INSTALLATION INSTRUCTIONS FOR CODE #1
MODIFICATION KIT #9010-14-00001 TO HXL-1
LINEAR AMPLIFIER

Installation Instructions for Code #2
Modification Kit #9010-14-00002
to HXL-1 Linear Amplifier

This bulletin has been prepared in order to provide you with the necessary information to eliminate a possible self-oscillating condition in the HXL-1 linear amplifier.

SCHEMATIC DIAGRAM
LINEAR AMPLIFIER (HXL-ONE)

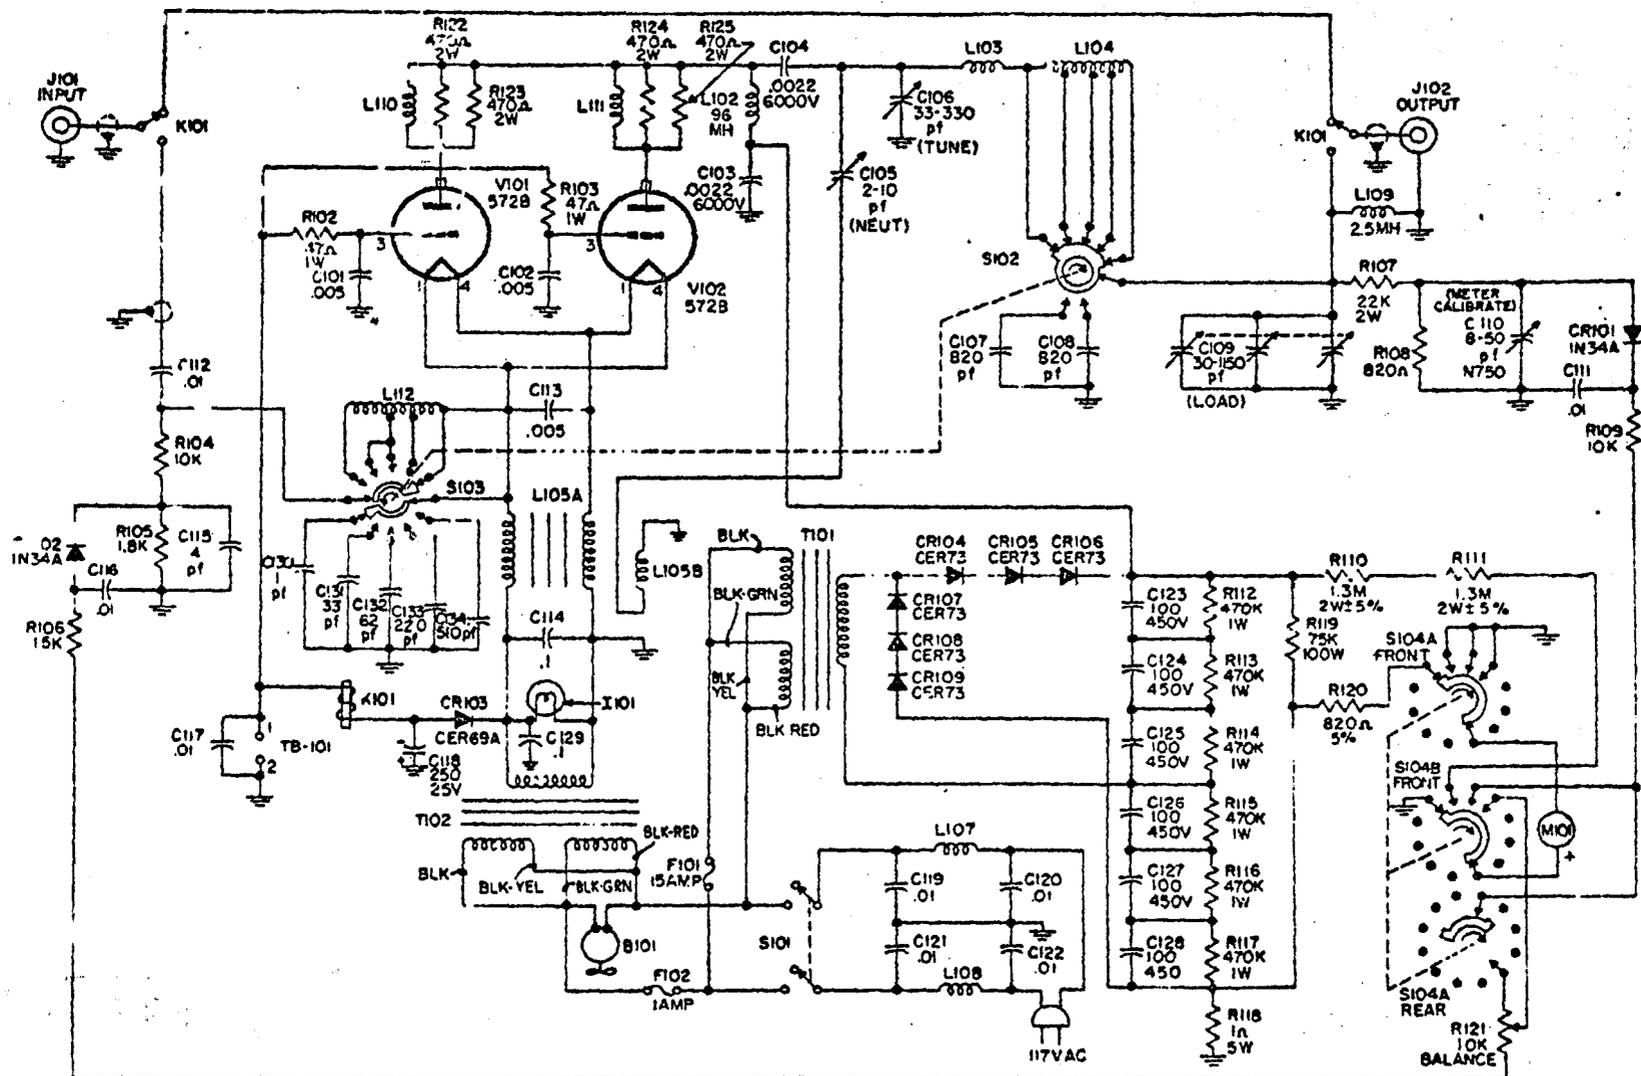
Disregard Schematic Diagram in present manual, use new Schematic Diagram attached to these instructions.

BOTTOM VIEW OF TUBE TRAY BEFORE CODE 2 MODIFICATION

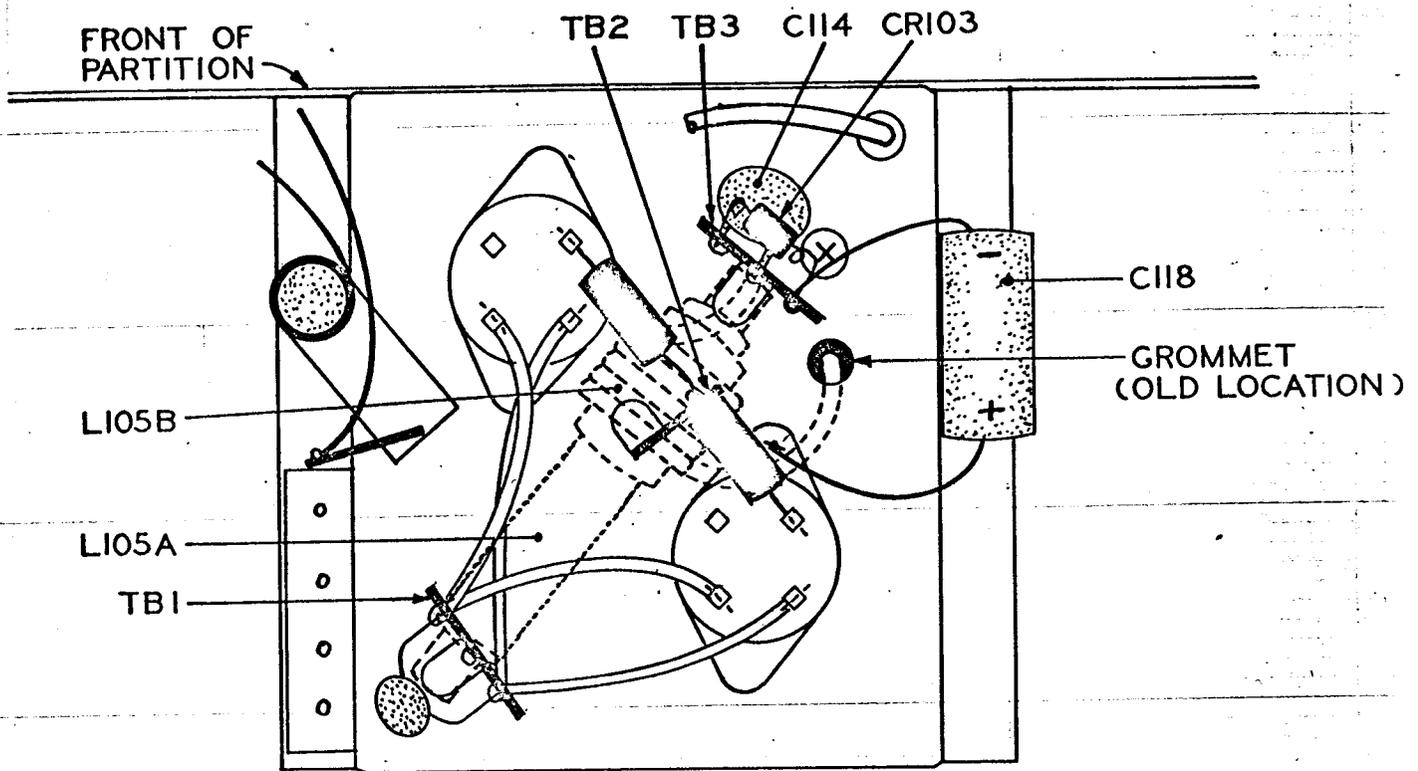
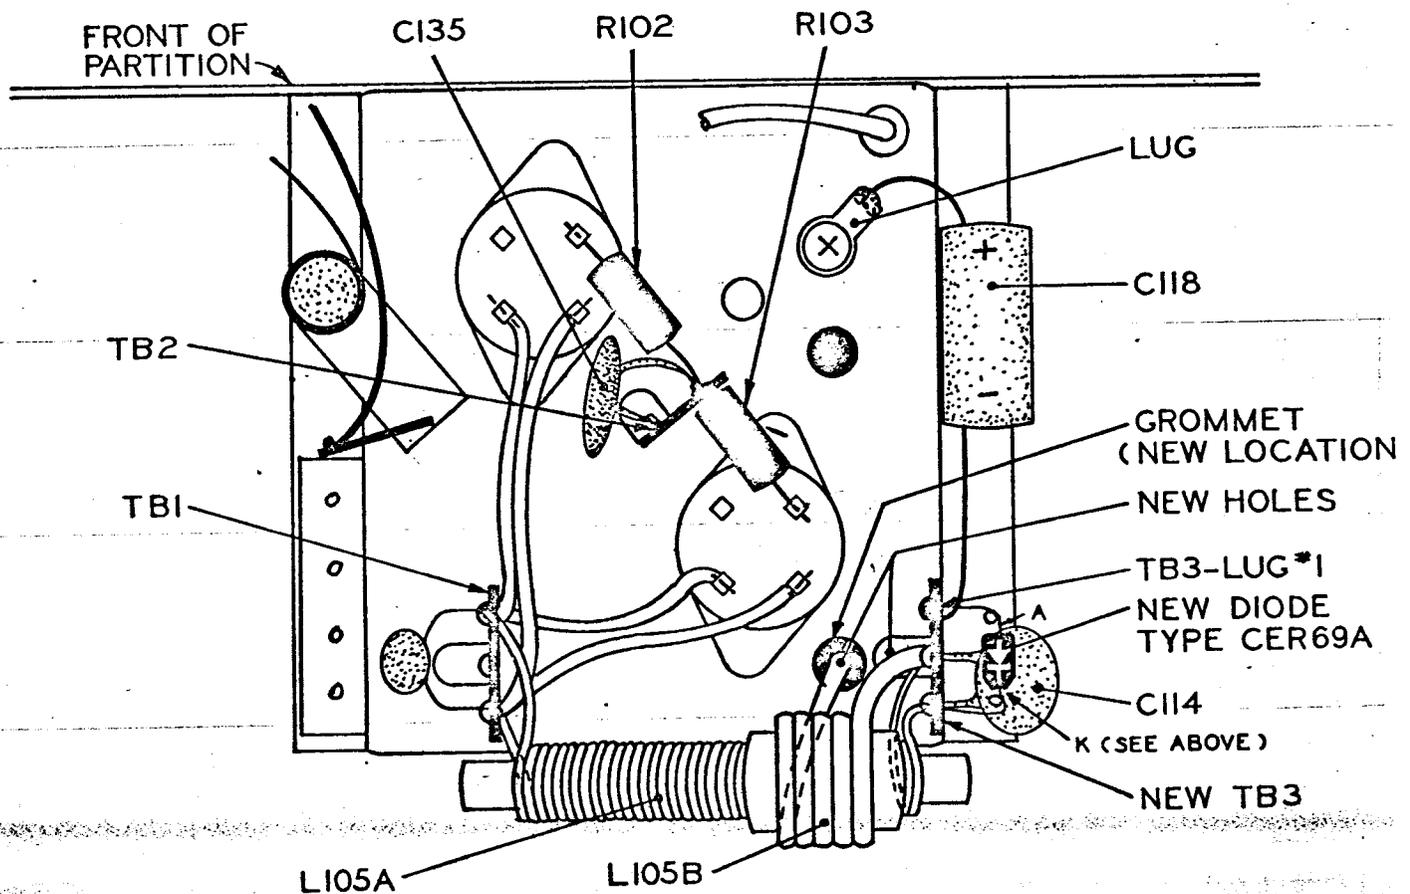
1. Unsolder and remove as a unit, L105A and L105B (Bifilar Coil Assembly).
2. Remove filament wiring (4 brown wires from TBl to Tube Sockets) and discard.
3. Soften solder on terminal strip TBl rivet and rotate terminal strip 45° clockwise until parallel with edge of tube tray, as per illustration.
4. Disconnect and remove C118, (250uf capacitor) turn 180° and remount; do not connect at this time.

5. Disconnect white blue and white black wires from terminal strip TB2 and TB3. Pull back to relay, twist together, dress across chassis to C118 and up to tube socket area.

6. Disconnect brown wire from TB3, pull back out of cable harness through square hole to front of partition, splice on 6 inches of wire, solder wires, tape junction and route along front of partition through hole in partition with RG8U coax and lay along side of tube tray near C118.

7. Unsolder red filament transformer leads from terminal strip TB3.
8. Remove diode (CR103) and .1 ufd disc (C114) from terminal strip TB3.
9. Remove terminal strip TB3 by breaking off. Leave rivet soldered to chassis.

10. Place a lug (Part #2888-26-01000) under the 10-32 screw that holds the plate choke.
11. Connect C118 Positive Lead to lug added in step 10 and solder.

12. Drill (2) holes in tube tray per attached drawing.
13. Mount new terminal strip (Part #2885-01-00012) in the small hole using screw and Keps nut and spot solder to tube chassis. This replaces the old terminal strip TB3.

15. Replace red filament transformer leads to the new terminal strip TB3, lugs 2 and 3. Keep the wires close together and close to the chassis.
16. Mount a new diode (Part #4804-02-00002) Type CER69A between lugs 1 and 3 of TB3. (Cathode end on lug 3, see bottom view, Page 4.)
17. Mount the new .1uf @100V disc capacitor (C114) to the new terminal strip TB3 between lugs 2 and 3.
18. Connect the C118 negative lead to the terminal strip TB3, lug 1.
19. Connect the brown lead from step #6 to the new terminal strip, lug 3.

20. Connect white/black lead to the new terminal strip, TB3, lug 1, Shorten wire to fit.
21. Connect white/blue lead to the junction of R102 and R103 on TB2. Shorten wire to fit.
22. Add a .01uf (Part #1509-01-01011) C135 disc capacitor to the same point as white/blue lead on TB2 and other end to ground; solder connections.
23. Add new filament wires between the tube sockets and the terminal strip (TB1) which was rotated in step 3. Keep the wires to each tube close together and close to the chassis. Solder at tube sockets.
24. Mount bifilar coil assembly (L105A) to the terminal strips. Connections to TB1 are as before. Connections to TB3 are as follows:
 - a. 2 bare leads from L105A to lugs 2 and 3 of TB3.
 - b. Covered heavy insulated lead from L105B to lug 2 on TB3.

Figure shows bifilar coil assembly (L105A & L105B) off to side of tube tray for better clarity of wiring. Assembly is to be mounted directly over terminal strips TB1 and TB3. This is necessary to insure proper operation.

BOTTOM VIEW OF TUBE TRAY SHOWING FIELD DRILLED HOLES
CODE 2 MODIFICATION - STEP 12

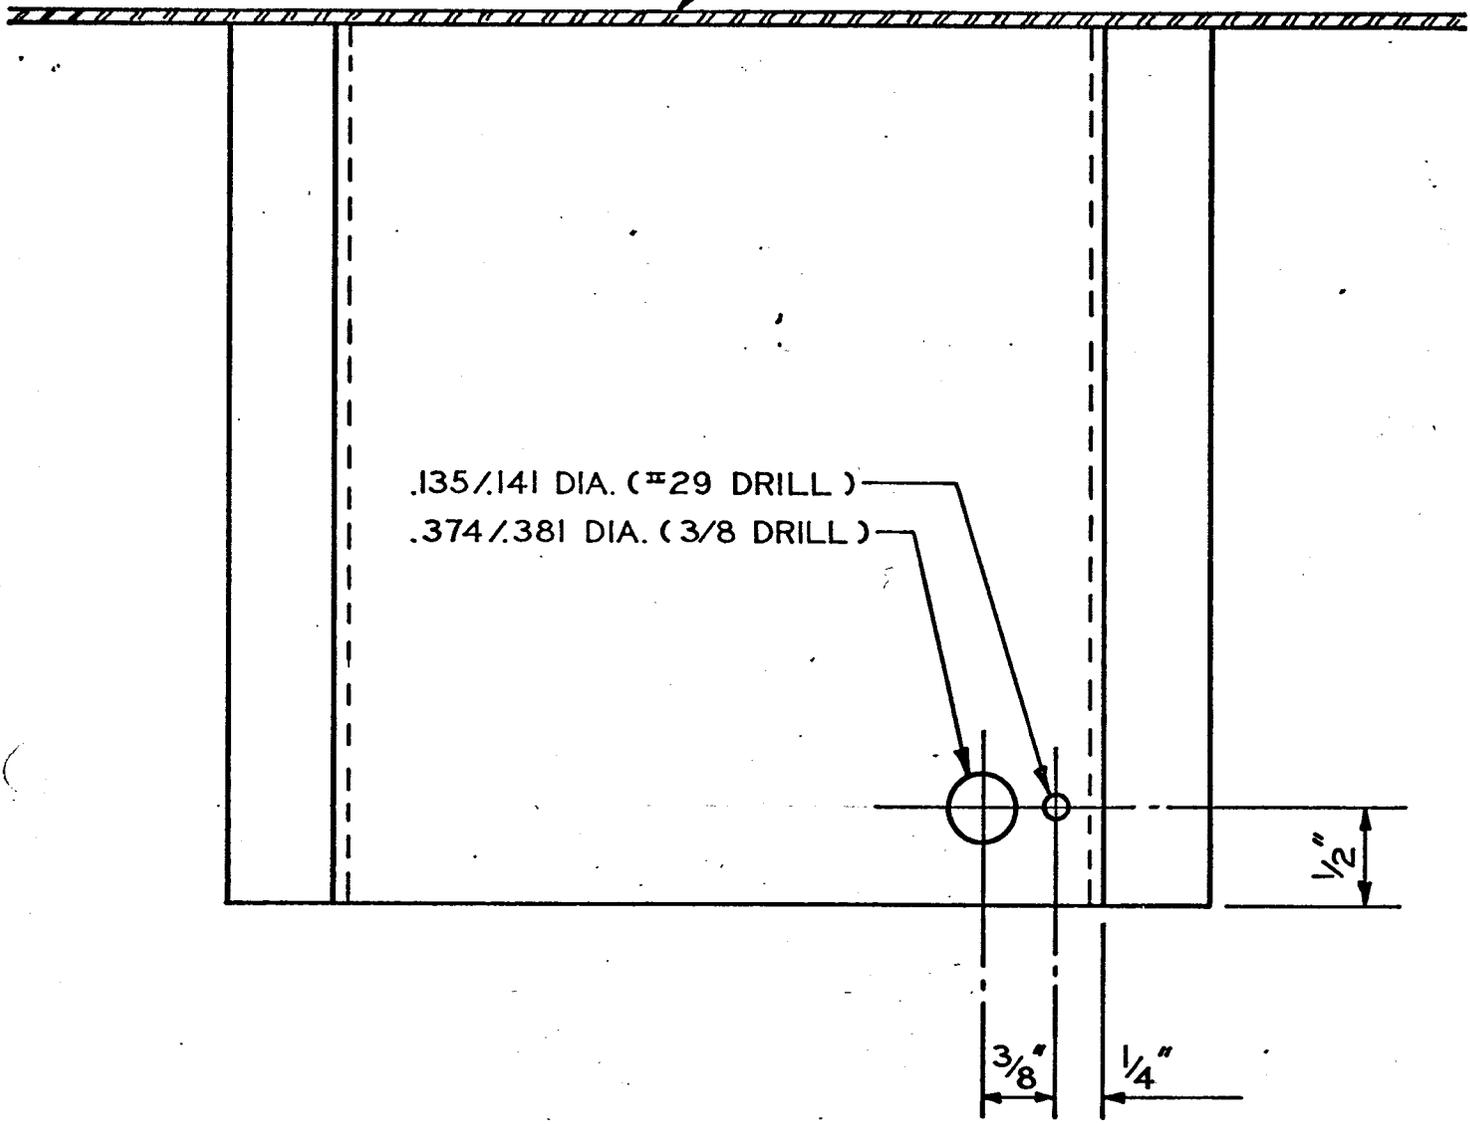
.135/.141 DIA. (#29 DRILL)
.374/.381 DIA. (3/8 DRILL)
